CITY PLAN COMMISSION STAFF REPORT

Kinsley Multi-Family Phase II

CD-CPC-2024-00033

Development Plan – Residential (major amendment)

Utility Plan Phase II

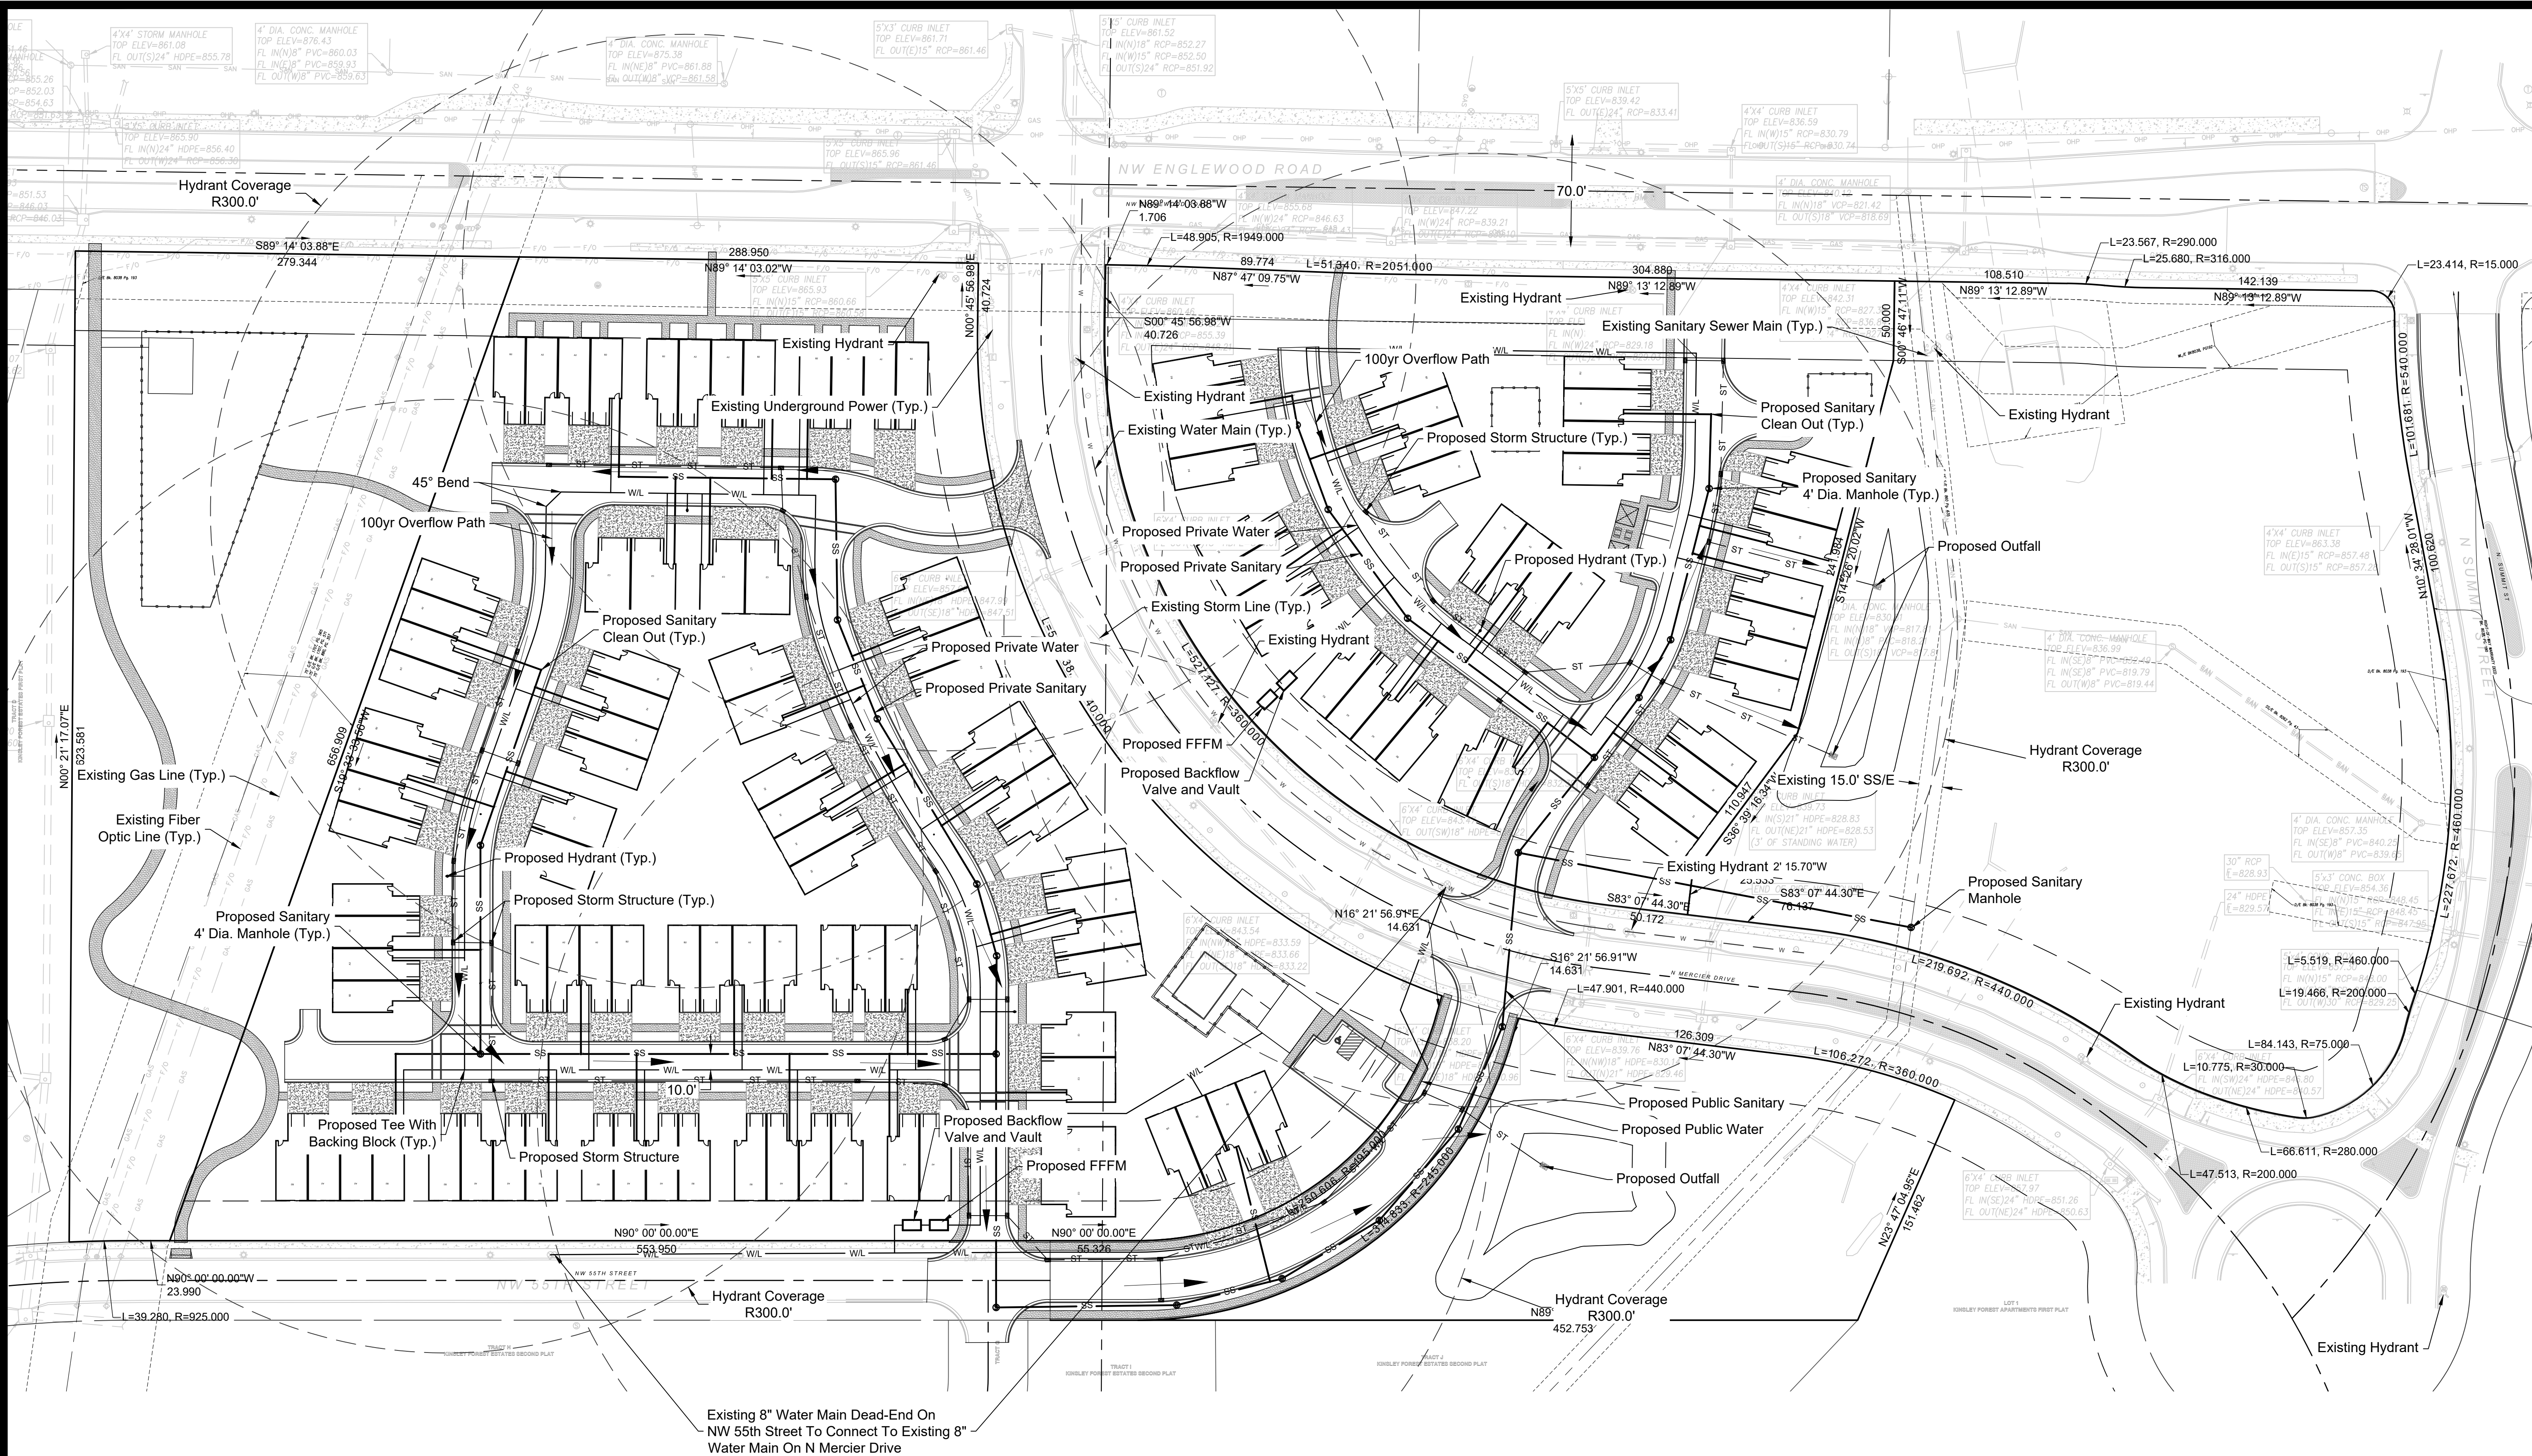
- E. The plan must provide for adequate utilities based on City standards for the particular development proposed.**
The site will be served with adequate public utilities. The public water main stubs in N Mercier Street and NW 55th Street will be extended in the extension of right of way proposed to close the utility loop.

38. Submit public water main plans following KC Water Rules and Regulations for Water Main Extensions. Plans and contracts shall be reviewed and approved prior to building permit issuance.

① C2 DUPLEX FRONT ELEVATION
1/4" = 1'-0"

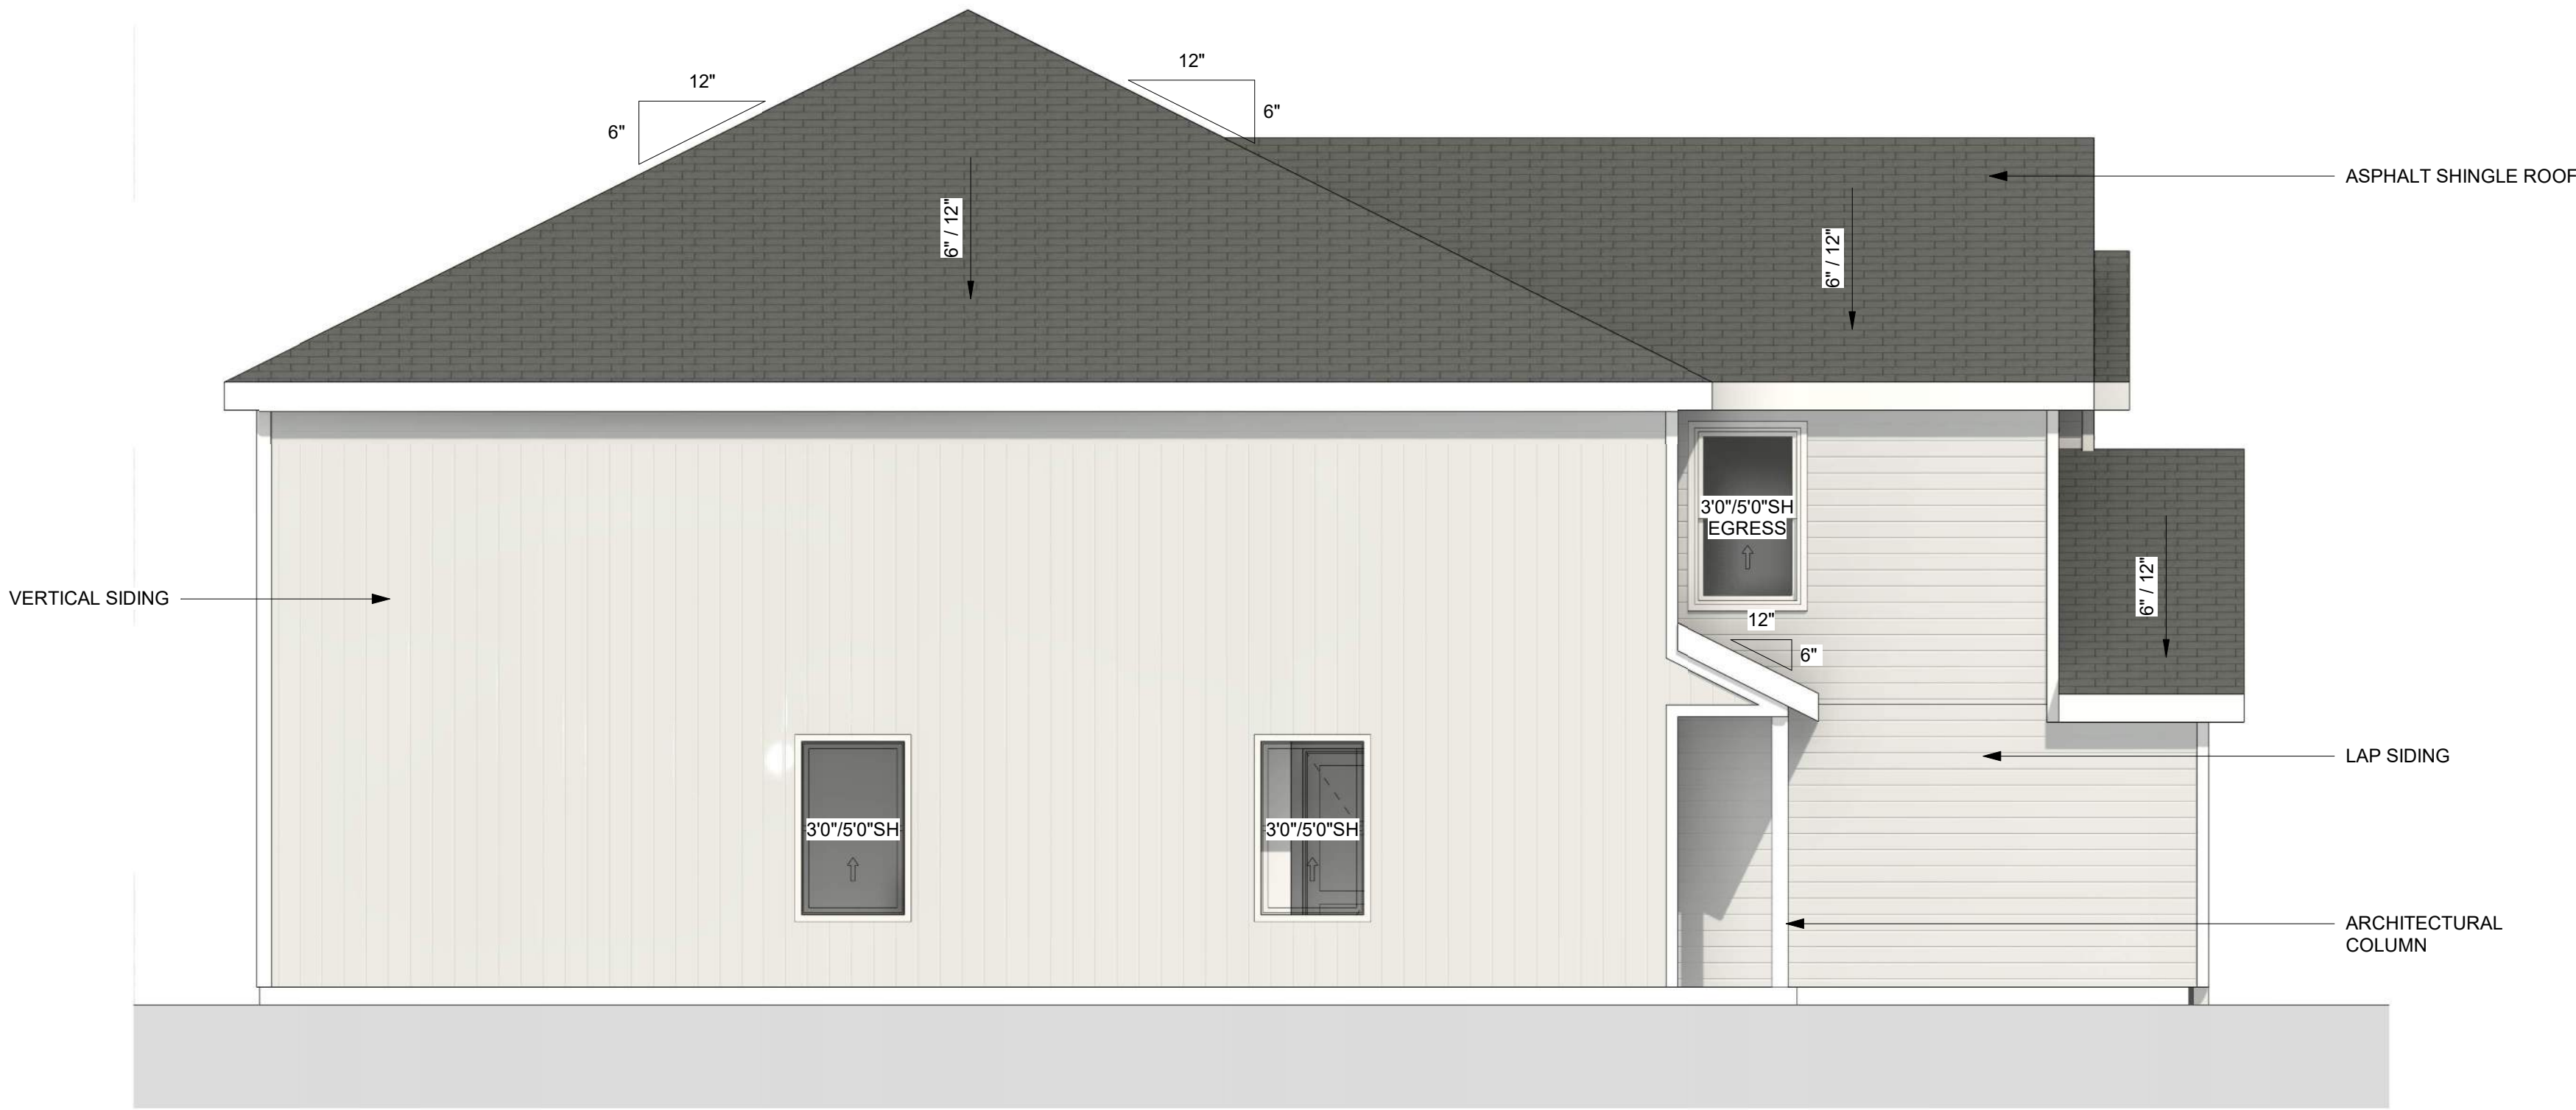
- F. The location, orientation, and architectural features, including design and material, of buildings and other structures on the site must be designed to be compatible with adjacent properties.**
Staff worked with the applicant to come up with appropriate building setbacks based on the boulevard standards and the setback of the existing residential buildings to the west. Staff provided the option of fronting the buildings on N Mercer Street and rear-loading off the private drive or providing a berm with landscaping to help screen the rear side of the buildings from N Mercier Street, which is the option the applicant chose. Although the applicant provided an entry element of awnings to the doors along NW Englewood Road, as required by the boulevard standards, staff feels the elevations provide the bare minimum and would prefer the level of architectural articulation as provided fronting the private drive on the garage façade. The Parks Department reviewer has conditioned the use of stone masonry on the facades facing NW Englewood Road.

32. The developer shall include the same stone masonry shown on the front elevations of the residential buildings for the quadplex facades front facing the Boulevard.
